FIRE SAFETY INSPECTION REPORT

ALIZA FASHION LTD.

ACCORD ID: 12187

April 11, 2015

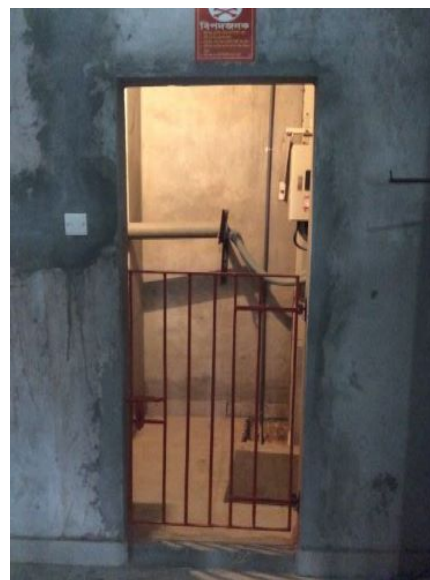
F-1	Fire Rated Construction	Unsealed electrical and mechanical shafts are located in the fire-rated floor/ceiling assemblies.	Provide a minimum 2-hr fire-rated shaft to separate the utility risers from each floor level and seal all penetrations in floor/ceiling assemblies to maintain the fire separation.	Within 3 months
-----	-------------------------	---	---	-----------------

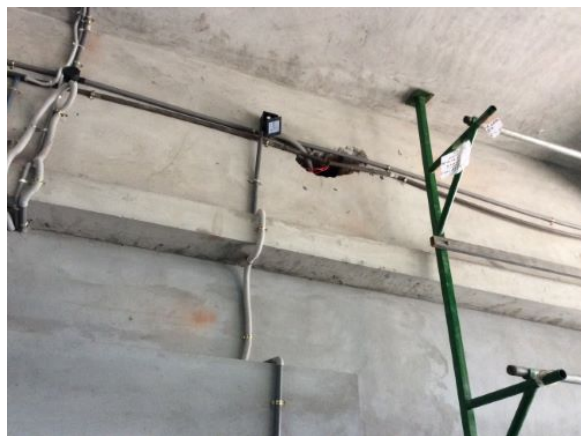
F-3	Fire Rated Construction	Unsealed penetrations and openings are located in east exit stair enclosure.	Seal all penetrations and openings in exit stair enclosure walls to maintain the fire separation.	Within 3 months
-----	-------------------------	--	---	-----------------

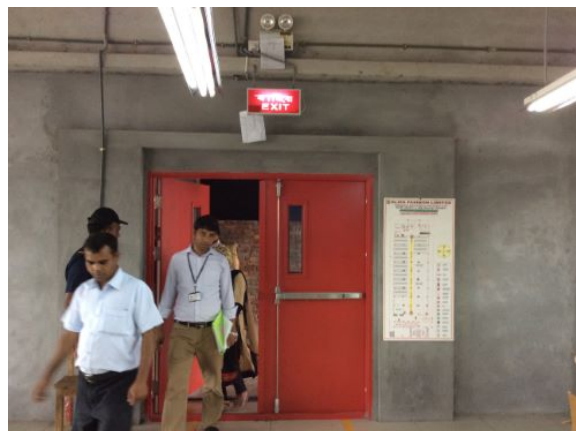
F-5	Fire Rated Construction	Storage boiler rooms discharges directly into east and west exit stair enclosures. Compressor room discharges directly into west exit stair enclosure.	Openings from exit enclosure to storage and utility spaces shall be provided with a vestibule with fire rated construction and openings. Provide a 1.5 hr. fire rated door on the exit stair side and a 1-hr. fire rated door on the storage and compressor room side. Ensure that the fire rating of the vestibule construction matches that of the exit stair enclosure.	Within 3 months
-----	-------------------------	--	---	-----------------

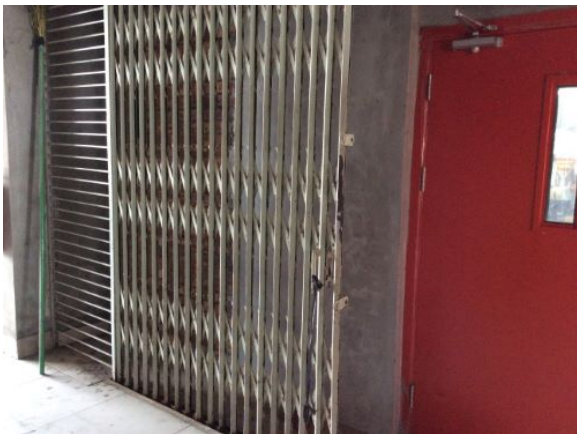
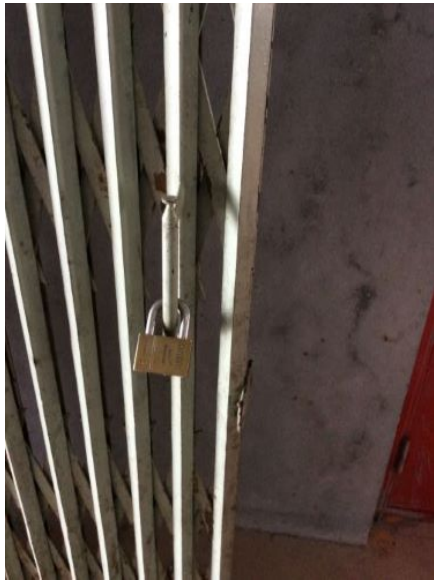
F-16	Egress	Collapsible gates are provided at exit stairs. Sliding doors are provided at exit stairs and along egress routes.	Replace all gates and sliding doors along the means of egress with side-hinged, swinging egress doors in accordance with ACCORD standard 6.8.1.	Within 1 month
------	--------	---	---	----------------

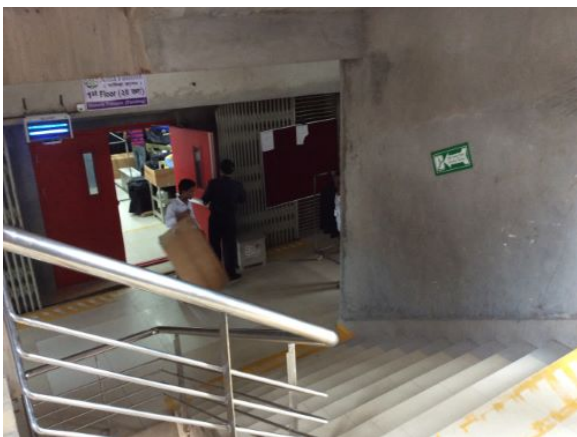
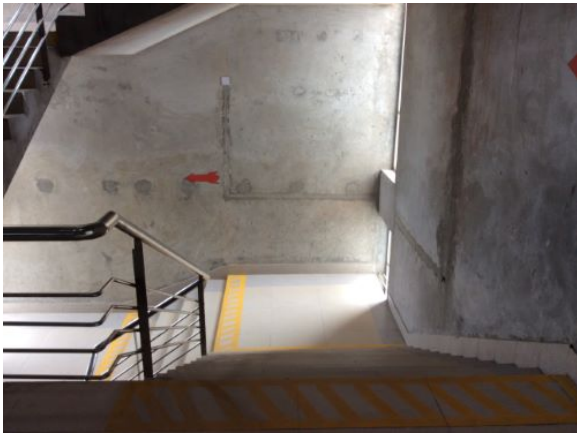
Dead-end aisles exceed 15 m (50 ft.) on second and fifth floors.

Reconfigure the egress arrangement to reduce the maximum dead-end distance to not more than 15 m (50 ft.).

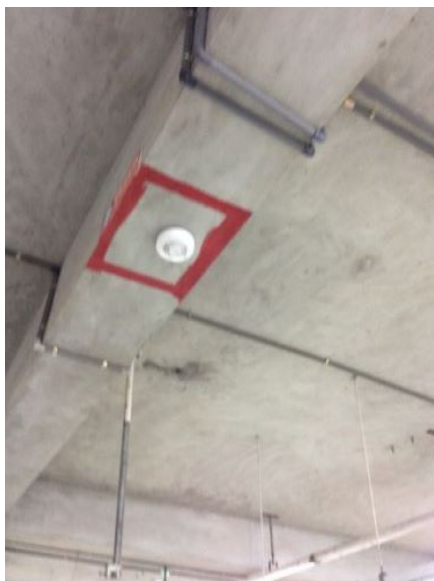
F-28	Fire Protection	The required standpipe system is not installed in accordance with the ACCORD standard.	Install a new standpipe system in accordance with ACCORD standard 5.4 and NFPA 14.	Within 6 months
			<p>A class III system shall be installed in buildings with the highest occupiable floor 10 m (33 ft.) above grade or more. A class I system shall be permitted in buildings protected throughout by an approved automatic sprinkler system.</p>
